**General Bid Bulletin No.7**  
**26 January 2021**

**IFB NO. 20-031-6**

**SOUTH COMMUTER RAILWAY PROJECT**  
**FOR PACKAGES CP S-04, CP S-05, CP S-06, AND CP S-07;**  
**CONSTRUCTION OF CIVIL STRUCTURES: VIADUCTS, BRIDGES,**  
**NINE (9) STATIONS, AND DEPOT**

**CP S04-07 Responses to Clarification Requests (Batch 1)**

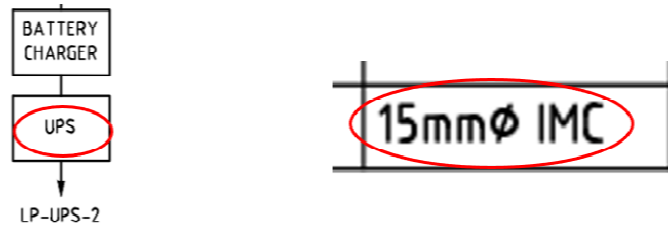
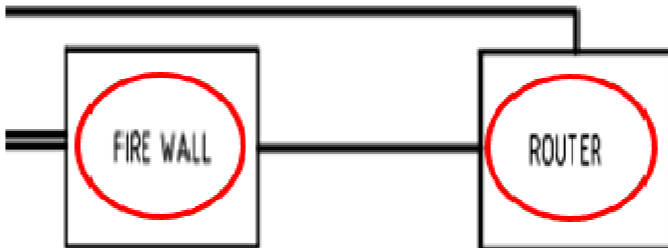
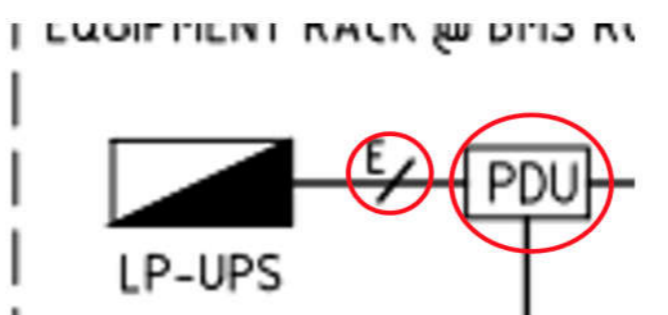
Packages	Vol	Sec	Page No.	Clause No./Title	Reference Text (if necessary)	Clarification Request	Final Response
S-04	3	Section 8 PCC	PCC-10	Part B – Specific Provision	“ad measurement” means focused measurement on change to limited items to show the increase or decrease in an item or limited series of items so that the cost saving or cost increase can be ascertained and reported. <b>It excludes comprehensive remeasurement</b>	We kindly request of the definition of an admeasurement contract and clear difference with remeasurement. In the GCC,” The conditions of Contract have been prepared for an ad measurement (unit price or unit rate) type of contract and cannot be used for other types of contract”	<i>Bidder is advised as follows; Clarification for Section 8 PCC page PCC-10 Part B - Specific Provision: The Works design is Detailed Design and the Bills of Quantities have been measured to reflect the Detailed Design. This means that with limited exclusions there will be no reason to remeasure the Works. Ad measurement is the measurement of change from the Detailed Design to the revised designs as instructed. This will not require wholesale remeasurement.</i>

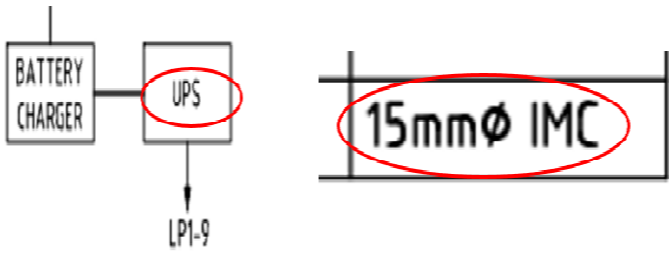
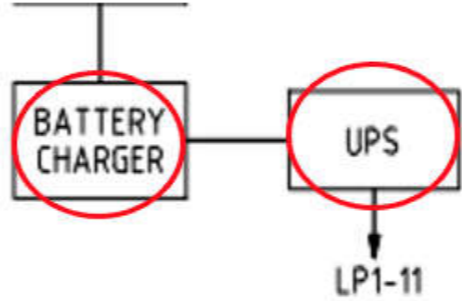
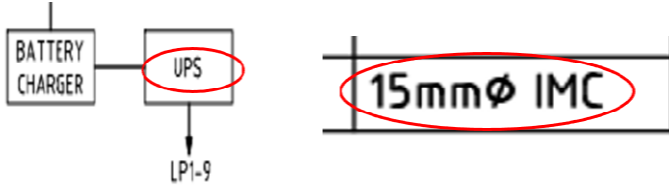
Packages	Vol	Sec	Page No.	Clause No./Title	Reference Text (if necessary)	Clarification Request	Final Response
S-04	2	Sec.6	GS90	128.1 Defect Liability	The Warranty Period for contractual spare parts, special tools and testing equipment or any other item of equipment delivered shall be thirty six (36) months (1,095 calendar days) from the date of delivery and acceptance by the Employer of such spare parts, tools and test equipment or any other equipment.	Please clarify the specific quantity for each spare parts items.	<i>Bidders are advised to refer to refer to relevant General Specifications and Technical Specifications to determine spare parts requirements.</i>
S-04	2	Drawing		NSRP-DWG-VIA00-ST-1201	Temporary Prestress Bar	As per drawing, NSRP-DWG-VIA00-ST-1201, type of temporary prestress bar for PSM viaduct is 40Ø, 29Ø VSL CT Stress Bar.  Please clarify bidder can propose equivalent type of prestress bar or the Client has any design preference.	<i>Bidder can propose the prestressing type for use. The Contractor will have a responsibility of the equivalent type of the system. Please refer to "TS208.3".</i>

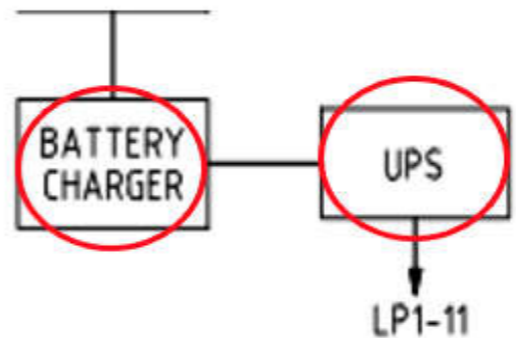
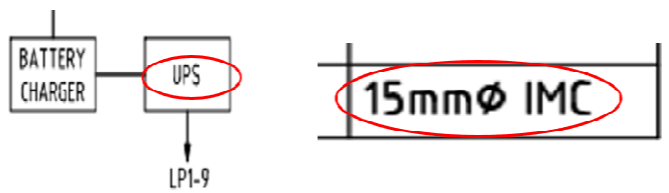
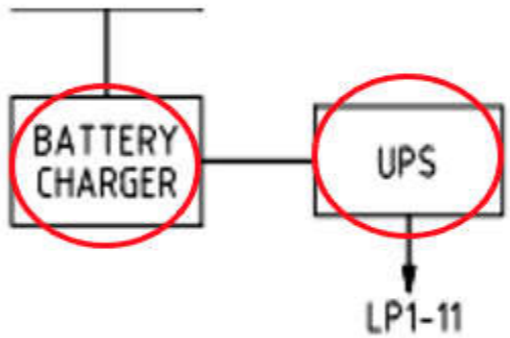
Packages	Vol	Sec	Page No.	Clause No./Title	Reference Text (if necessary)	Clarification Request	Final Response
S-04	2	02.Book2.04-S04 ELEC. CP S-04-03-ALA-EL	- NSRP-DWG-ALA -EL-5701	FIRE DETECTION AND ALARM SYSTEM SCHEMATIC DIAGRAM		 <p>We can't find out some items in the BOQ. But the items are in the relevant drawings. Please clarify that as following items;</p> <ul style="list-style-type: none"> <li>- UPS</li> <li>- 15 mm dia IMC Conduit</li> </ul>	<i>Bidder is advised that pay item for UPS is included in 706(11)am ALA - LP UPS incl 30kVA UPS. Quantity for 15mm dia IMC is already included in 707(4)i 20mm dia IMC as circuit LP-UPS/2.</i>
S-04	2	02.Book2.04-S04 ELEC. CP S-04-03-ALA-EL	- NSRP-DWG-ALA -EL-5803	CCTV SYSTEM DIAGRAM UNPAID AREA		 <p>We can't find out some items in the BOQ. But the items are in the relevant drawings. Please clarify that as following items;</p> <ul style="list-style-type: none"> <li>- FIRE WALL and ROUTER</li> </ul>	<i>Bidder is advised that cost for Fire wall &amp; router is included in pay item 715(1)e Server</i>

S-04	2	02.Book2.04-S04 ELEC. CP S-04-03-ALA-EL	- NSRP-DWG-ALA -EL-5825	ACCESS CONTROL SYSTEM SCHEMATIC DIAGRAM		 <p>We can't find out some items in the BOQ. But the items are in the relevant drawings. Please clarify that as following items;</p> <ul style="list-style-type: none"> <li>- PDU and cable E</li> </ul>	<i>Bidder is advised that cost for PDU &amp; cable E is included in pay item 715(2)b Access Control Panel</i>

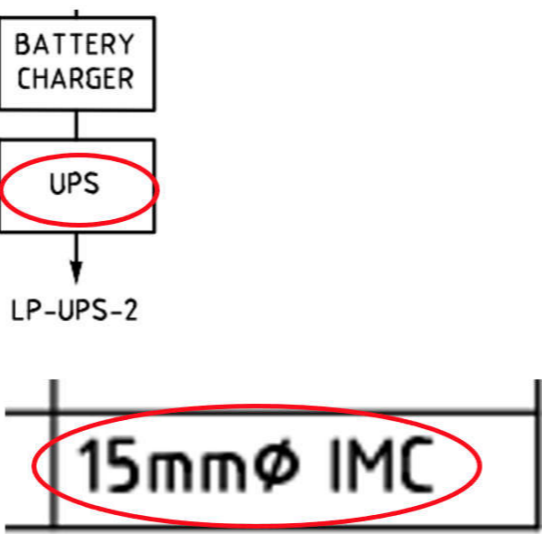
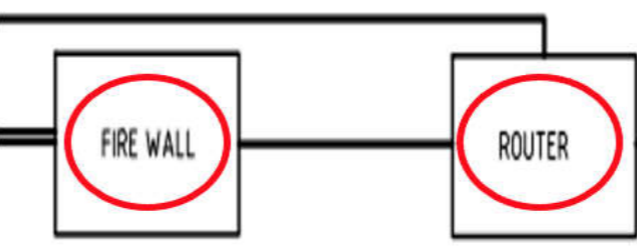
S-06	2	Section 6 Drawing	32		CP S-06_Vol-4 Site Data - Topo Surveys	From P-1253N to P-1259N, there are no plan to be diverted for existing tracks. Calamba station is interfaced with existing tracks. Please clarify it to bidders.	<i>Bidder is advised that the PNR track will be also diverted in this section. The end point of diversion will located south side from end of CPS06.The bidder should take into account of the actual condition of PNR relocated alignment by PNR</i>
S-06	2	Section 6 TS	TS-200-52	204.2.6.2 204.2.6.3 206.18.3.2 217.2.2		Please provide the detail information of 'Licensed professional engineer' and 'Registered professional engineer'	<i>Bidder is advised to follow Philippine Engineer Licensing practice in relation to this requirement.</i>
S-06	2	Section 6 Drawing	VIA00-167, VIA00-169			There are two emergency staircases which are #6 and #7. The height of Beam FTB1 is 1200mm in the NSRP-DWG-VIA00-ST-1693. But its dimension is 600mm in the NSRP-DWG-VIA00-ST-1695. Please, clarify it.	<i>Bidder is advised that in the NSRP-DWG-VIA00-ST-1693 drawing, the height of the corner including the pile joint is 1200 mm. The height of the FTB1 beam is 600 mm.</i>
